PART 5: Planning Applications for Decision

Ref: 22/03353/FUL

Location: Land Adjacent To 31 Heath Road, Thornton Heath, CR7 8NF

Description: Erection of two-storey three-bedroom detached dwelling

Figure 11: First floor plan showing the previously refused development

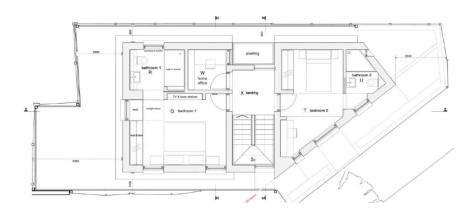
8.25 Notwithstanding this, the massing of the proposed dwelling has been increased and is closer to the rear boundary at first floor level. In comparison, the increased massing also measures the full width of the rear elevation. At ground floor level, the proposed dwelling would be approximately 9.15m from the rear elevations of 8 and 8A Furze Road. The separation distance would be approximately 9.5m at first floor level. No.8A has ground and first floor windows in the rear elevation which serve habitable rooms. No.8 Furze Road also has ground and first floor windows on the rear elevation which appear to serve habitable rooms, as well as a part-width single-storey rear addition which accommodates a kitchen with windows on both the side and rear elevations. Both Nos.8 and 8a have short rear gardens.

- 8.26 The ground floor level of the proposed dwelling would not be particularly visible given the boundary treatments. However, given the proximity to the rear boundary of the site, as well as the proximity to the rear elevations of Nos. 8 and 8a, the bulk and massing would appear visually imposing when viewed from the rear windows of 8 and 8a Furze Road and would harm the outlook of these properties due to the overbearing nature of the proposed development.

- 8.27 In comparison to the previous scheme, the proposal has also introduced additional first floor windows in the western side elevation facing towards the rear gardens of 6 Furze Road. There is also a first-floor window in the rear elevation facing towards 8 and 8A Furze Road. If the application had been otherwise acceptable, a condition could have been added requiring the lower part of the first-floor windows on the side and rear elevations to be obscured and non-openable to avoid unacceptable overlooking.
